Office Action Summary	Application No. 10/806,872	Applicant(s) SUMMER, STEVEN E.	
	Examiner Bao Q. Vu	Art Unit 2838

DETAILED ACTION

FIG. 2

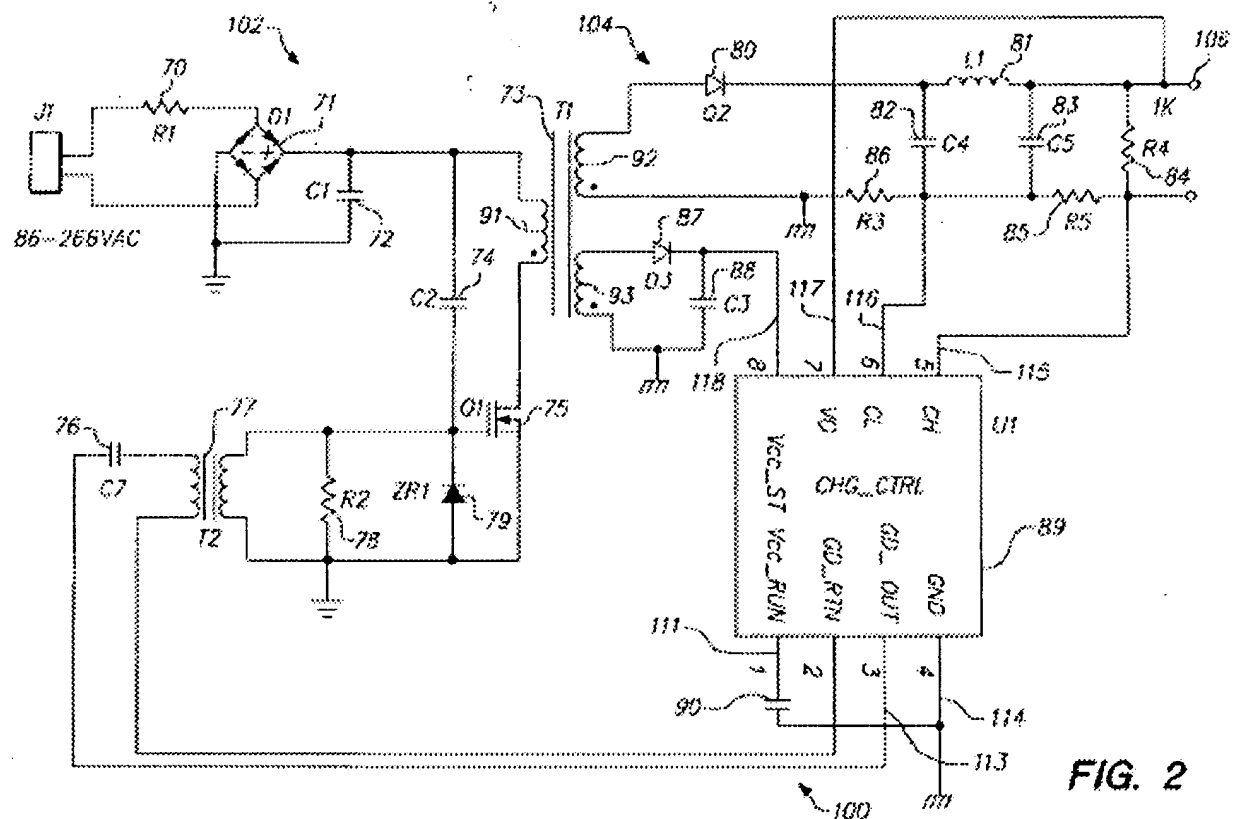
Claims 1-12 and 19-23 are rejected under 35 U.S.C. 103(a) as being unpatentable over Wong (USP 6,456,511) in view of Shimashita (USP 5,661,642). Wong discloses the

claimed invention (see figure 3 below), a drive circuit, a drive pulse transformer (T2), a de-coupling capacitor (C1), an output rectification circuit (80), a capacitor (C7) connected between the pulse width modulator and the primary windings, a zener diode (ZR1), a bleeder resistor (R2), a flyback transformer (T1), a rectifier diode (80, 87) except for the isolation circuit that is used to isolate the input line from the output line. Shimashita discloses that it is known in the art to provide the isolation circuit that is used to isolate the input line from the output line. Shimashita discloses an isolation (15) circuit that is used to provide a clean signal for the control of the switching circuit. It would have been obvious to one having ordinary skill in the art at the time of the invention was made to provide the isolation (15) circuit that is used to provide a clean signal for the control of the switching circuit of Shimashita with the drive circuit, a drive pulse transformer (T2), a de-coupling capacitor (C1), an output rectification circuit (80), a capacitor (C7) connected between the pulse width modulator and the primary windings, a zener diode (ZR1), a bleeder resistor (R2), a flyback transformer (T1), a rectifier diode (80, 87) of Wong, in order to provide a signal that is cleaner and has less noise and electrical effects that would tend to contaminate the signal without an isolation circuit.
